# Service Bulletin

Bulletin No.: 18-NA-346

**Subject:** Vehicle Will Not Start and/or Service Electronic Steering Column Lock System Message Displayed on Driver Information Center (DIC)

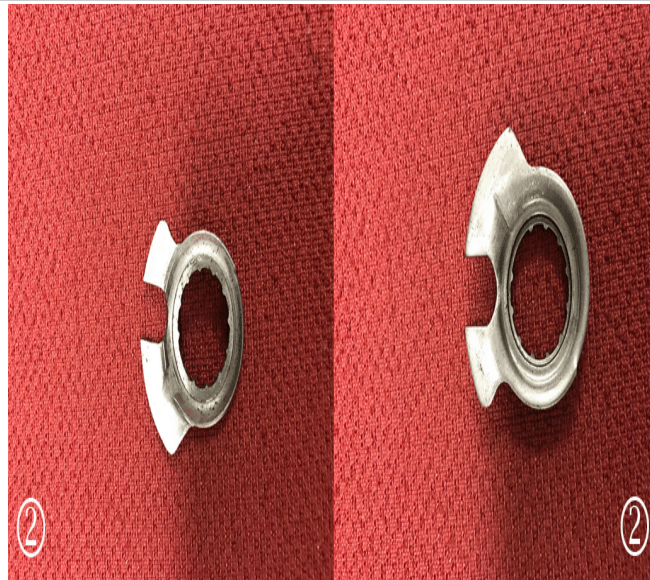
Replace the steering column lock plate (1) with the new plate (2), and update the BCM with the new utility file.

Service Programming System

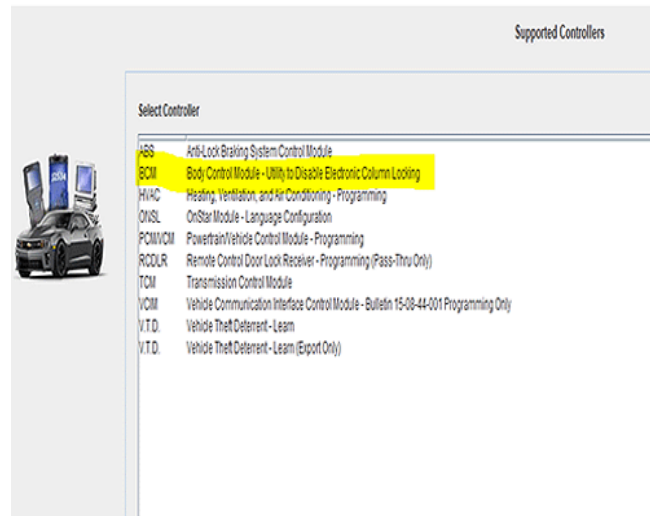
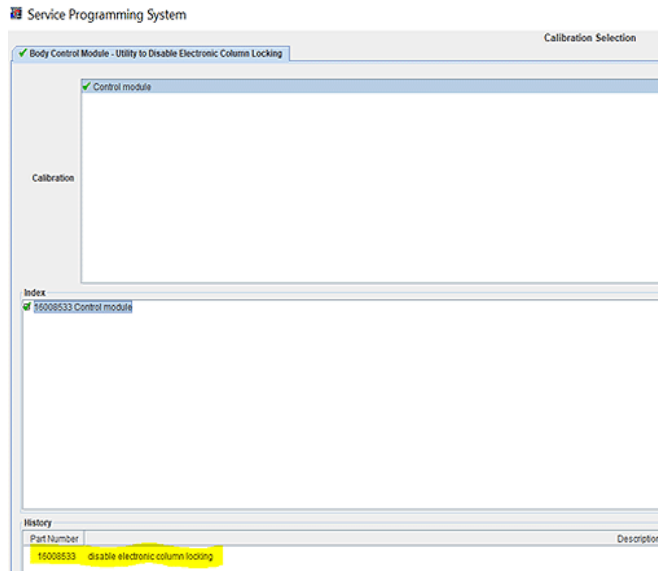
The technician needs to electrically disable the electric steering column lock in the SPS menu.
